January 23, 2017 WO 3915

City of Auburn Mechanics Row Garage Phase 3 Repairs – Addendum 1

SK1

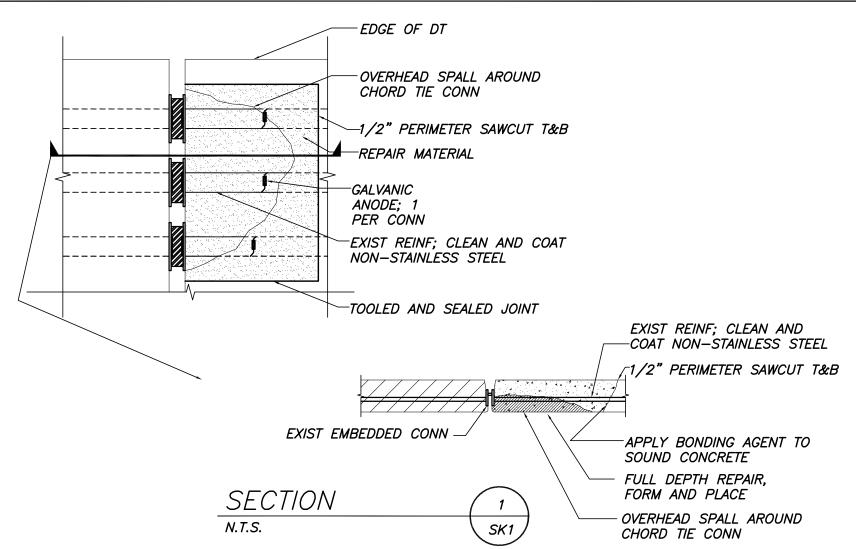
Item #2 Sketch SK-1 It was brought to the attention to the City that an overhead spall had formed at the precast double T chord connections at Level 1 within the proposed Phase 3 work area. The attached sketch outlines the location and proposed repair.

- 1. SOUND OUT DETERIORATED CONCRETE.
- 2. PROVIDE 1/2" DEEP SAWCUT ALONG PERIMETER OF REMOVAL AREA AT TOP AND BOTTOM OF PRECAST FLANGE.
- 3. REMOVE DÉTERIORATED CONCRETE UNTIL SOUND CONCRETE IS REACHED AND CORROSION ON REINFORCEMENT IS NOT VISIBLE.
- 4. ALLOW ENGINEER TO REVIEW EXPOSED CONDITION PRIOR TO FORMWORK BEING INSTALLED.

- 1. CLEAN ALL STEEL SURFACES REMOVING ALL RUST, SCALE AND DETERIORATED COATING TO SSPC—SP3 (POWER TOOL CLEAN).
- 2. ALL NON—STAINLESS STEEL REINFORCEMENT SHALL BE PRIMED OR EPOXY COATED WITH A PRODUCT COMPATIBLE WITH THE CONCRETE REPAIR MATERIAL.
- 3. FORM WORK SHALL BE DESIGNED AND CONSTRUCTED TO SUPPORT THE REPAIR MATERIALS AND VEHICLE LOADS IF REQD.
- 4. FORMS SHALL BE CONSTRUCTED TO FIT TIGHTLY AGAINST EXISTING CONCRETE SURFACES.
- 5. REPAIR AREA SHALL BE COMPLETED WITH A PRE-PACKAGED MATERIAL WITH SHRINKING COMPENSATING AND CORROSION INHIBITING ADDITIVES.
- 6. PROVIDE TOOLED JOINT AROUND REPAIR PERIMETER AREA AND SEAL WITH SEALANT.
- 7. MATERIAL SHALL BE PLACED AS PER SPECIFICATIONS AND PER MANUFACTURERS RECOMMENDATIONS.
- B. FORM WORK, SHORING AND TEMPORARY PROTECTION SHALL REMAIN IN-PLACE UNTIL MATERIAL ACHIEVES A MINIMUM STRENGTH OF f'c=4.000 PSI MIN.
